Groundwater Transfer Review Summary Form

Transfer/PA # T- 14101

Application: T-14101

Applicant Name: Andrews Holdings, LLC

Figure 1. Well location Map

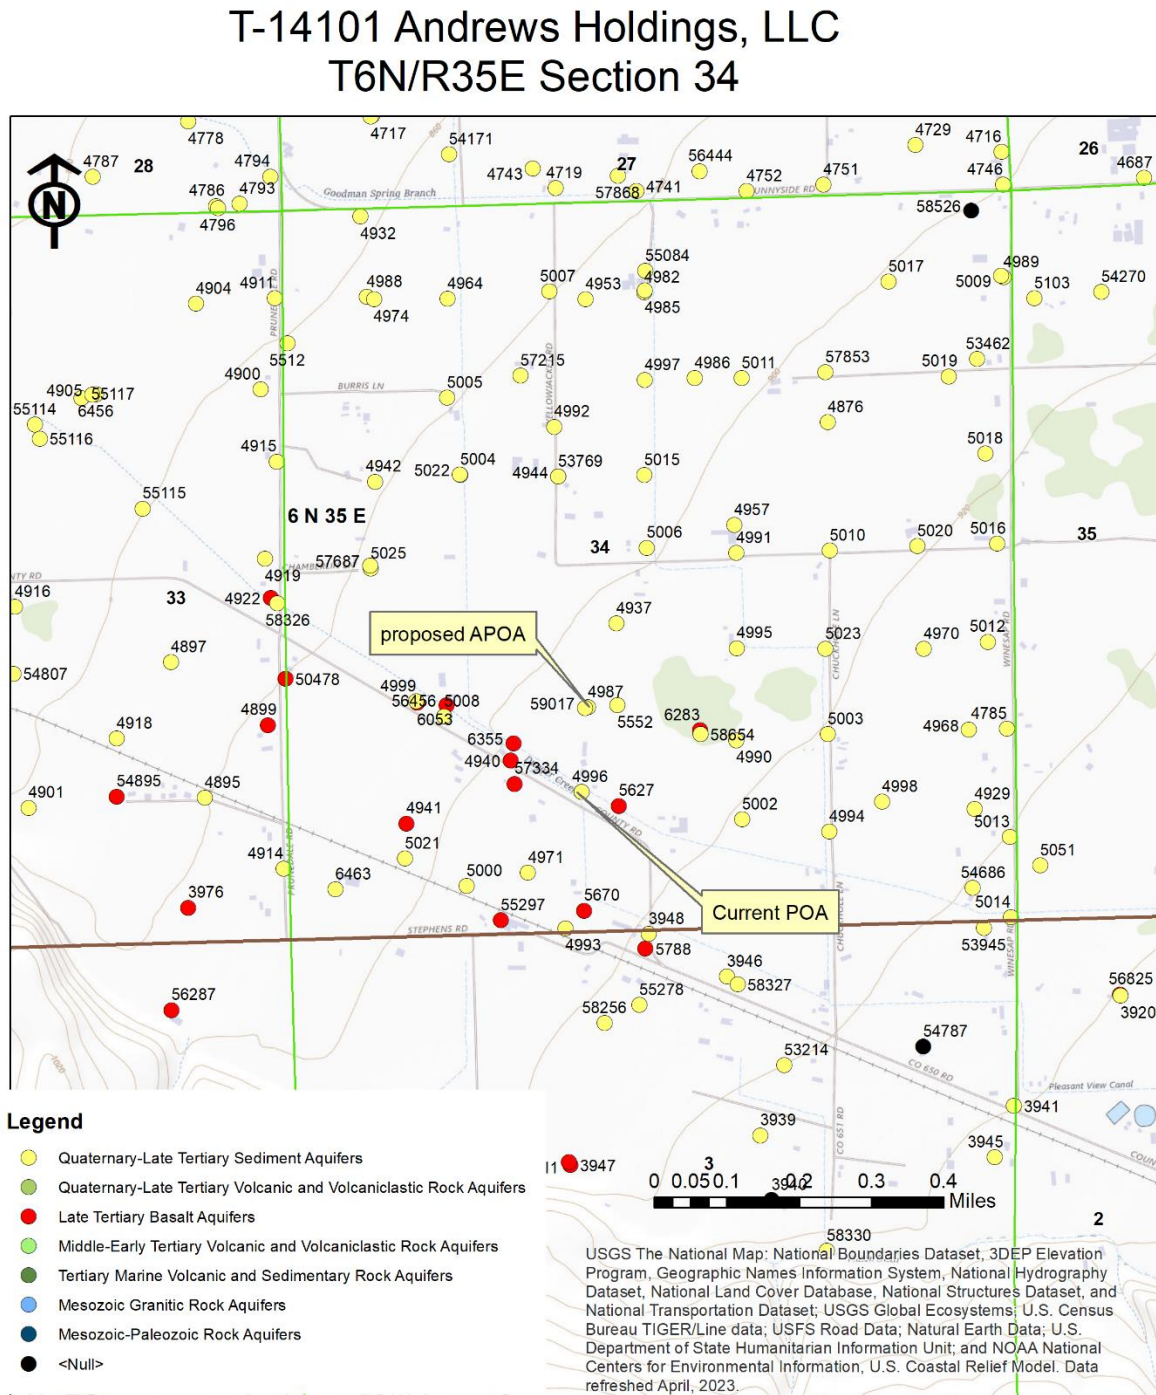
4. a) Will this proposed change, at its maximum allowed rate of use, likely result in an increase in interference with **another ground water right**?
☒ Yes ☐ No Comments: The replacement well is located approximately 600 feet north of the authorized POA. This will change well-to-well interference with UMAT 5552, decreasing the distance between the authorized POA and UMAT 5552 from 600 feet to 300 feet.

Figure 2. Well to well interference estimates

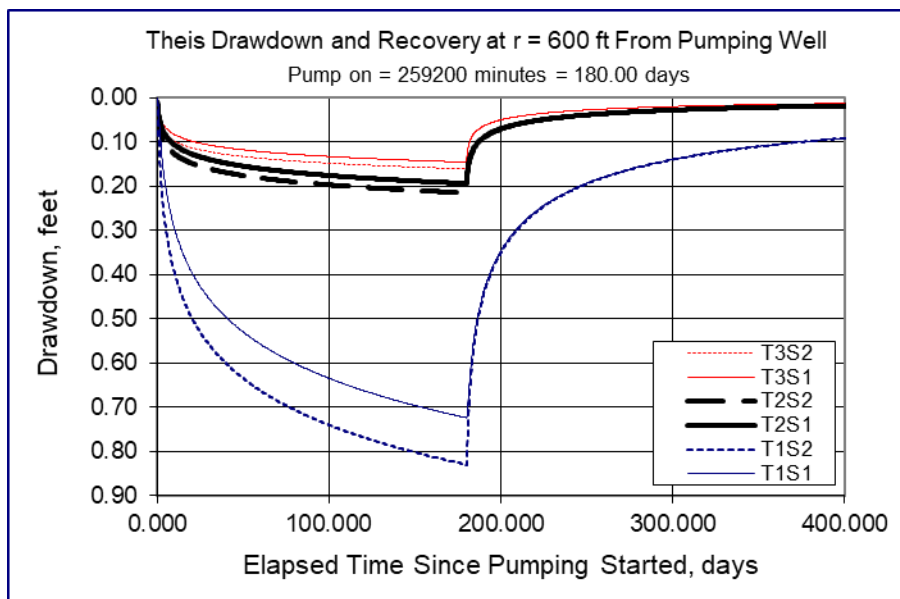
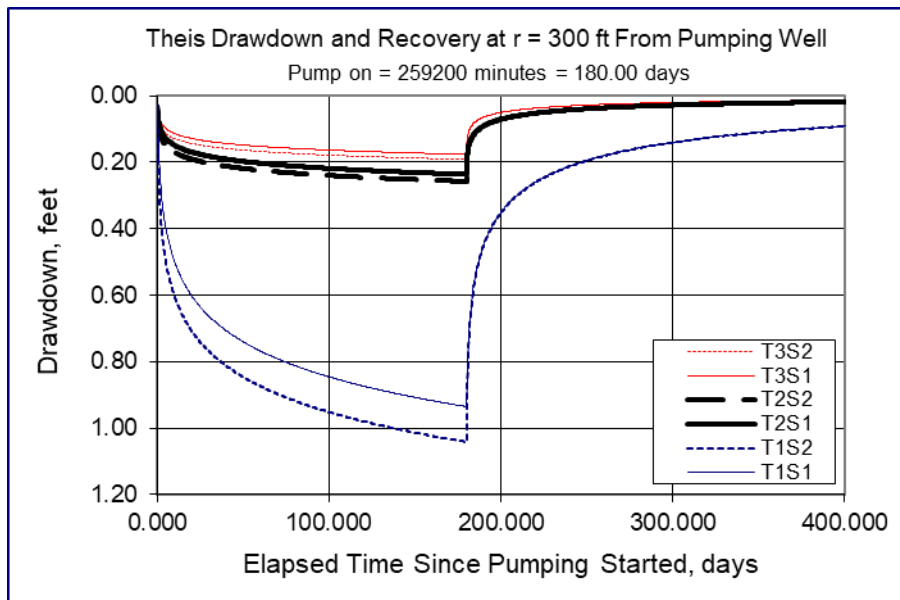
- b) If yes, would this proposed change, at its maximum allowed rate of use, likely result in another groundwater right not receiving the water to which it is legally entitled?
☐ Yes ☒ No If yes, explain: As shown in Figure 2, drawdown increases approximately 0.2 feet after 180 days of pumping, when the distance between wells decreases from 600 to 300 feet. Aquifer parameters are from a multi-well pumping test by Petrides (2012). This degree of interference will not prevent other groundwater users from accessing groundwater.
